ADDENDUM

NO. 2

PROJECT NAME: New Operations Building

ADDENDUM DATE: Thursday, January 29, 2026

1 FLOOR PLAN - LEVEL 1 - AREA D - WAREHOUSE

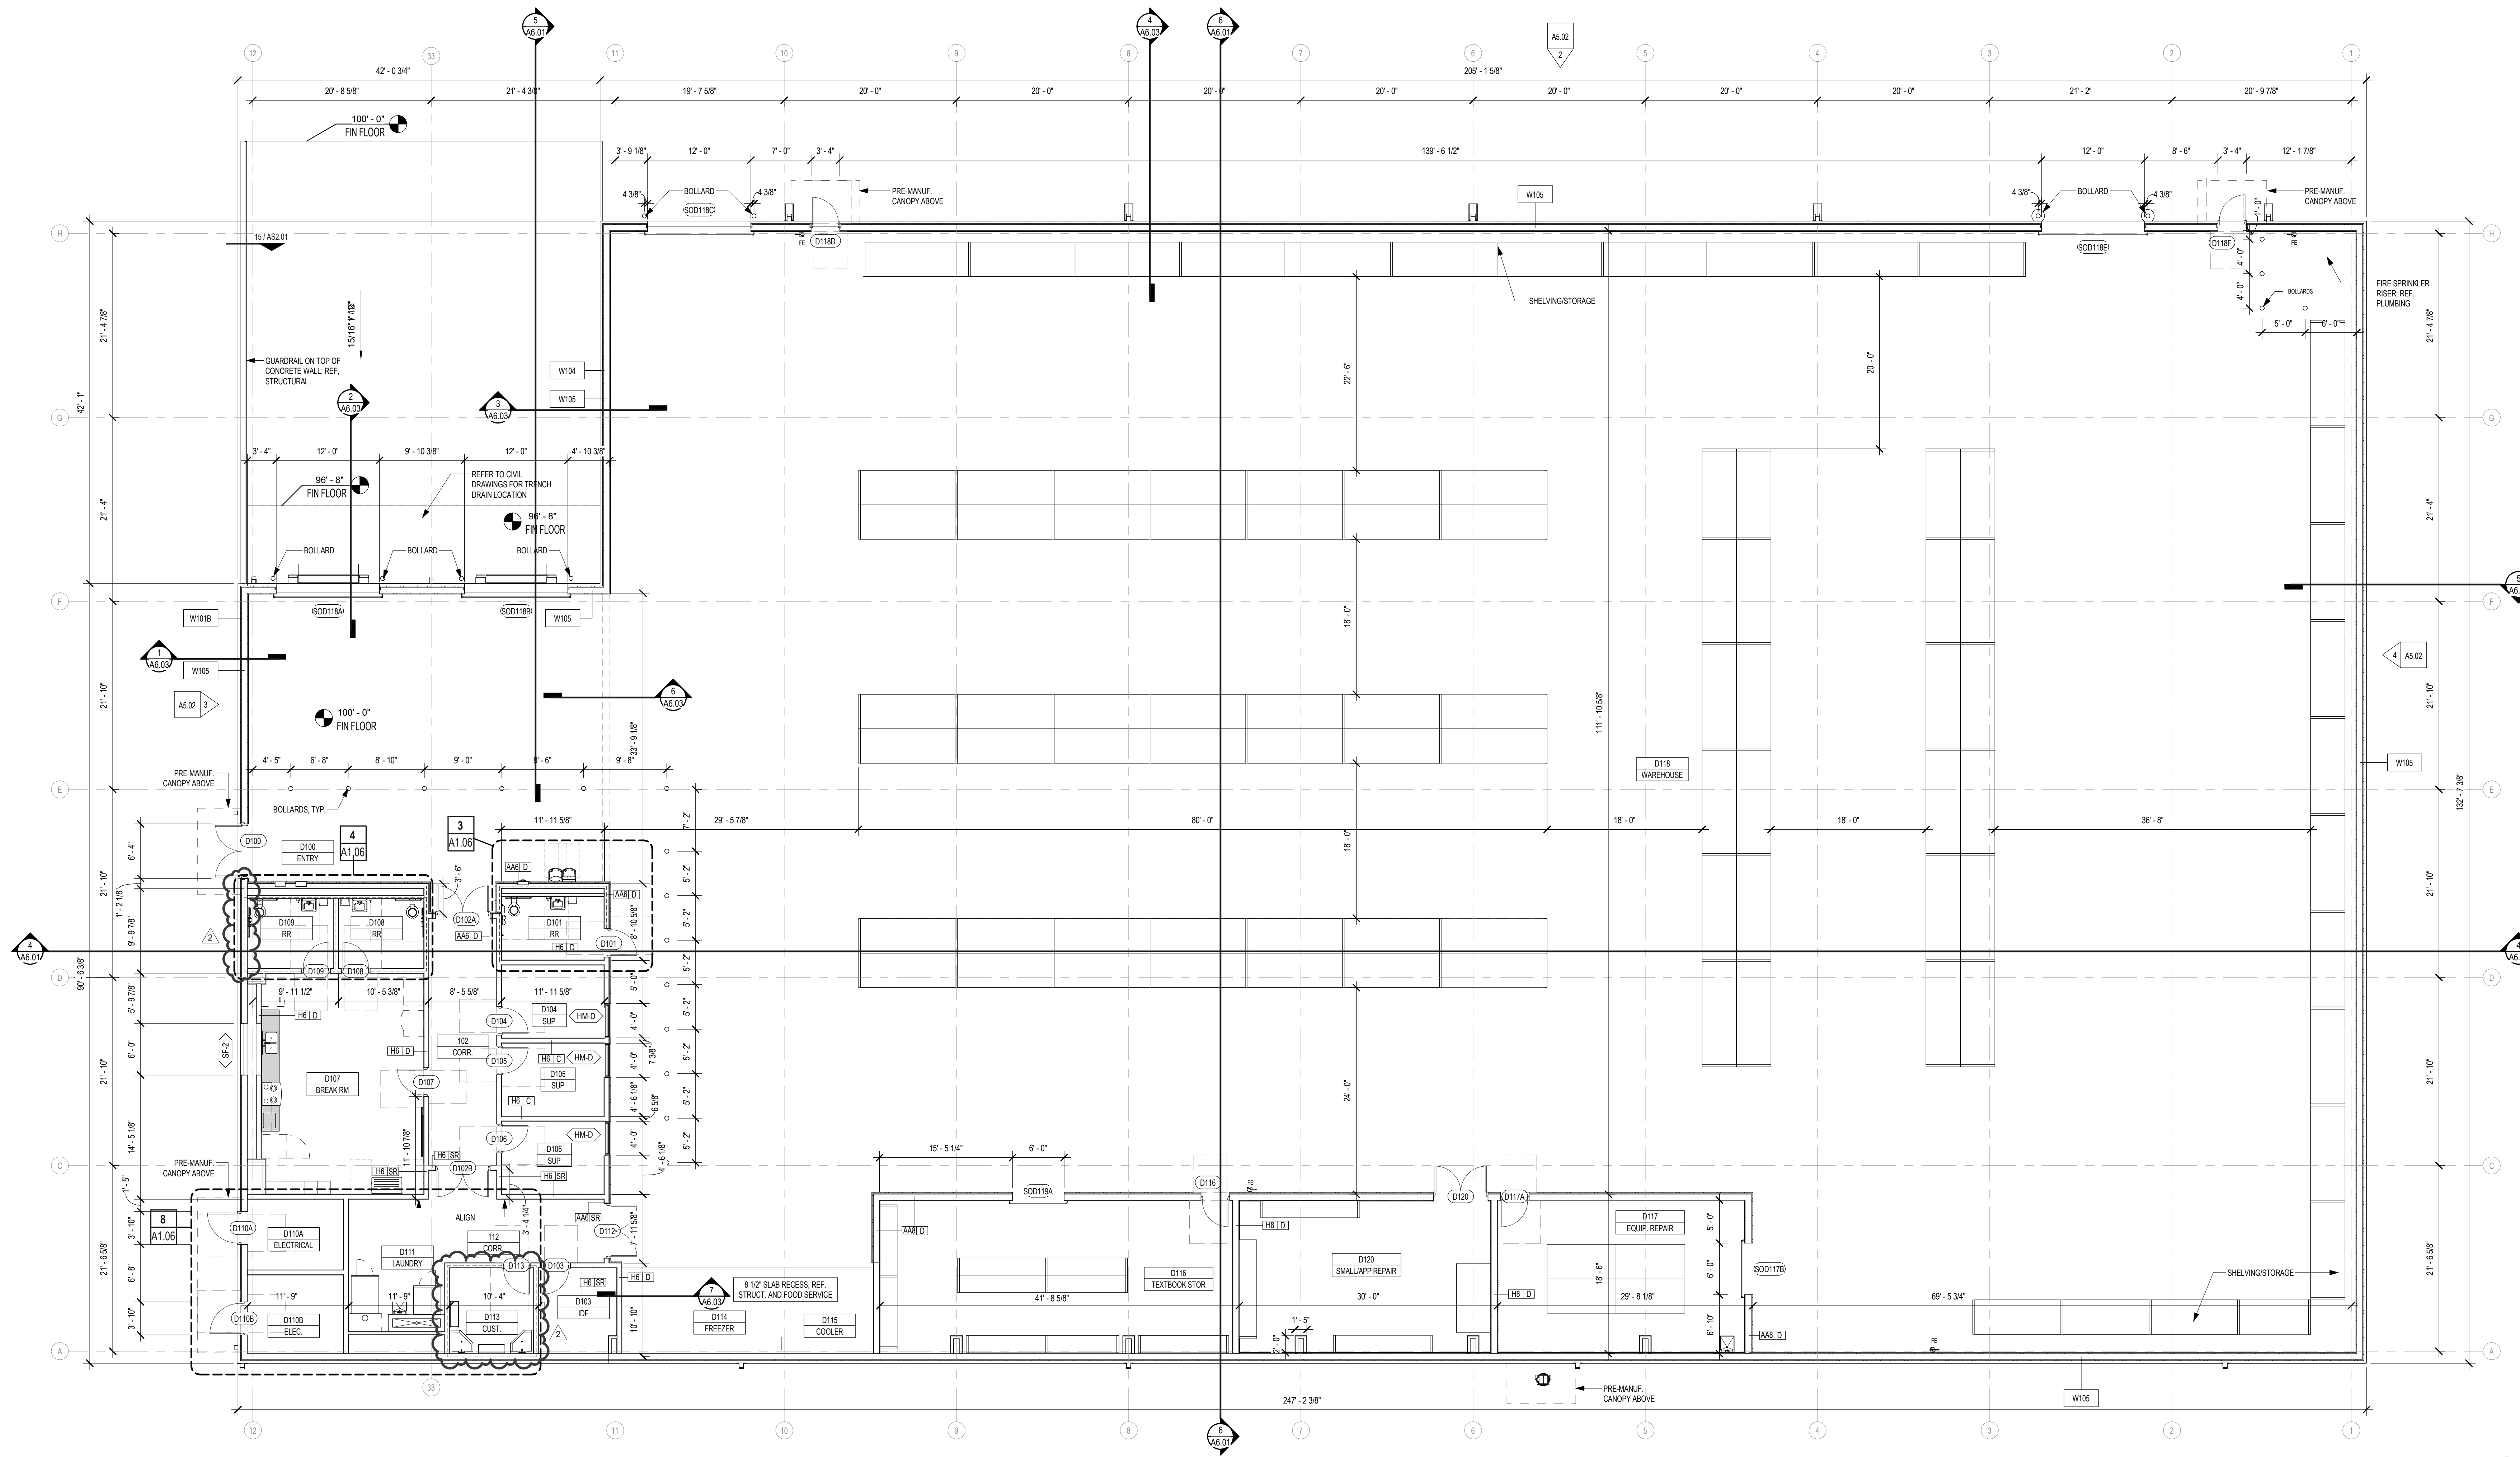
AD No 2, Arch. Item 4: To the Drawings, Sheet A1.04, “FLOOR PLAN – LEVEL 1 & 2 – AREA A & C – OPERATIONS BUILDING”

- 1) 1 - FLOOR PLAN – LEVEL 1 – AREA D – WARHOUSE, **ADD** concrete curb designation and **REVISE** wall partition tags at RR D109 and CUST D113 as indicated per attached revised sheet.

6 TYPICAL CONCRETE CURB DETAIL
1 1/2" = 1'-0"

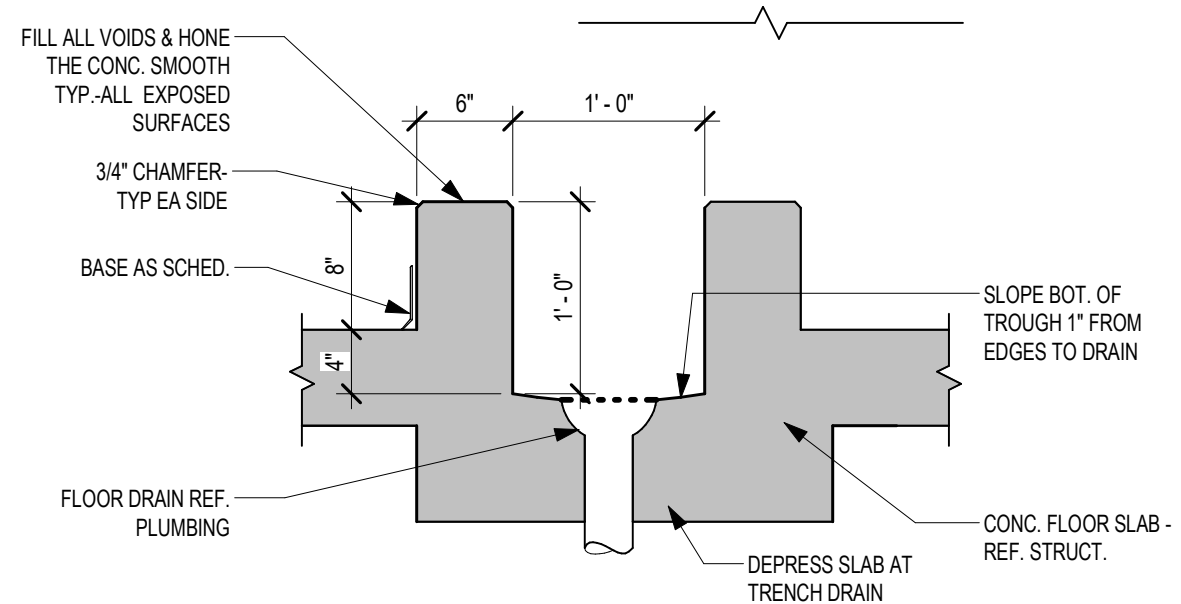
AD No 2, Arch. Item 6: To the Drawings, Sheet A9.01, “TYPICAL DETAILS”

- 1) **REVISE** Detail 6. TYPICAL CONCRETE CURB DETAIL as indicated per attached revised sheet

PLUMBING FLOOR PLAN - LEVEL 1 - AREA B - OPERATIONS BUILDING

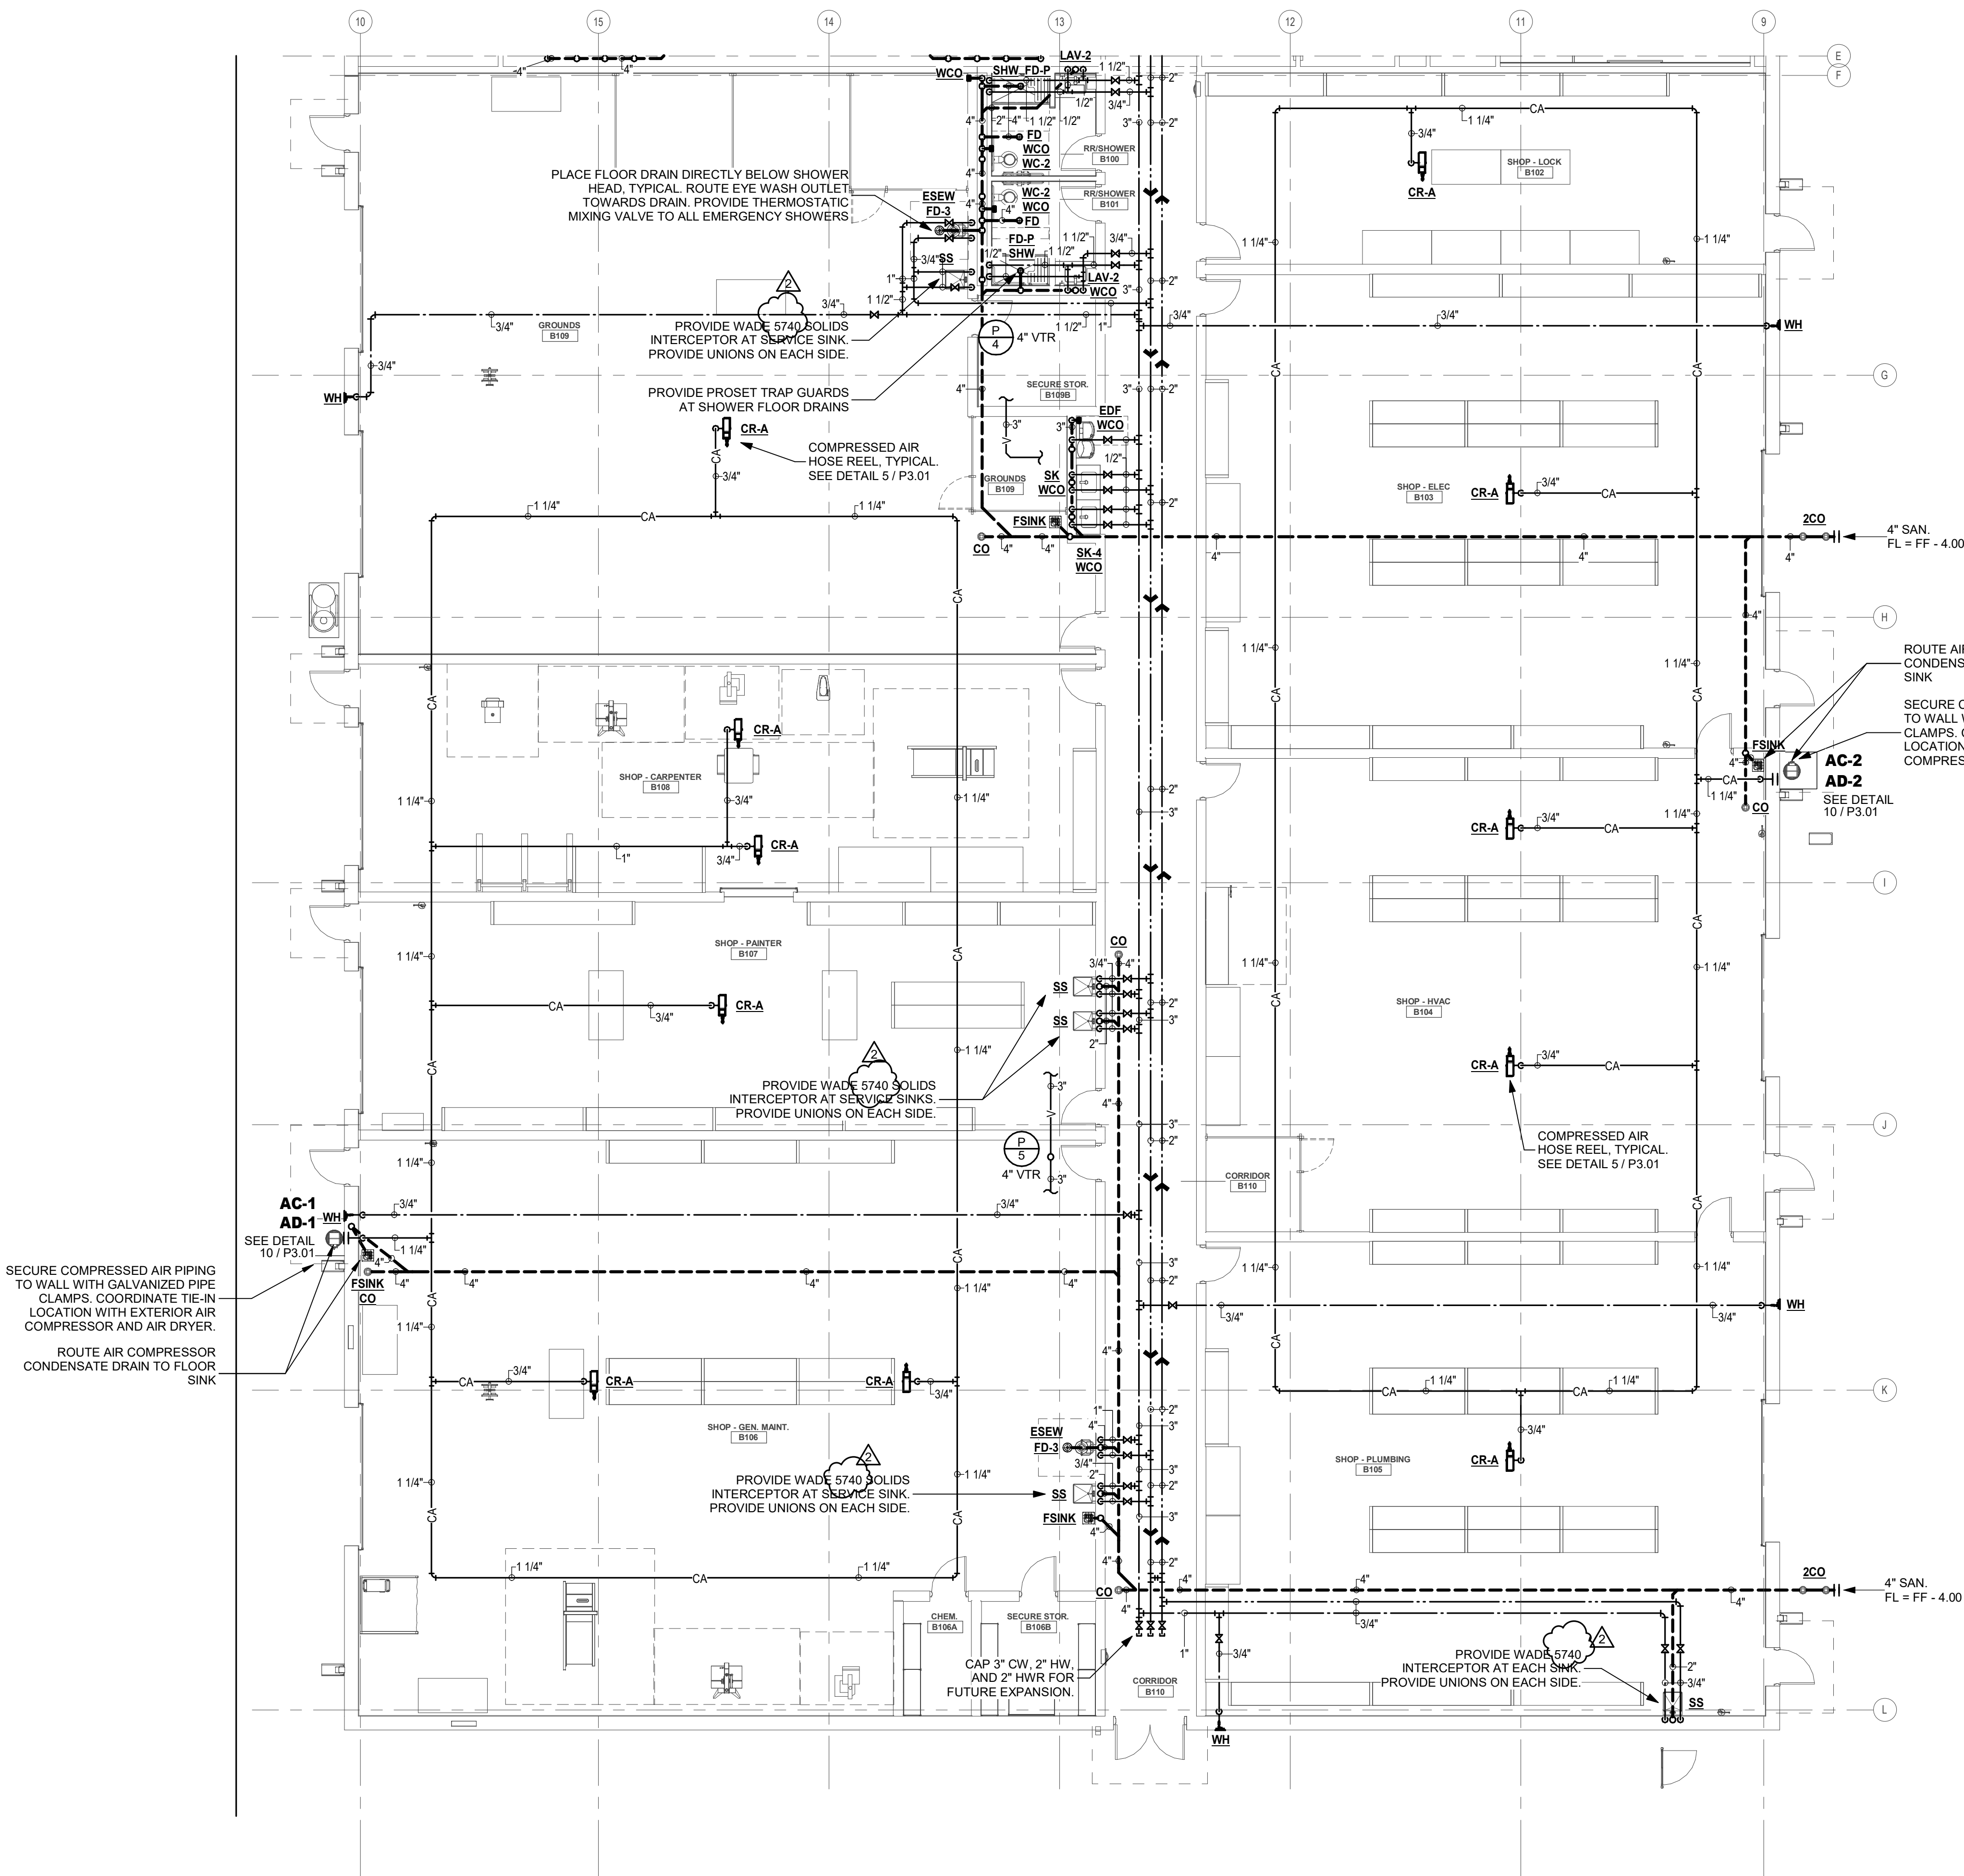
AD No 2, Plumb. Item 8: To the Drawings, Sheet P1.03, "PLUMBING FLOOR PLAN – LEVEL 1 – AREA B – OPERATIONS BUILDING,"

- 1) Corrected model numbers for the solids interceptors in the shop sinks.
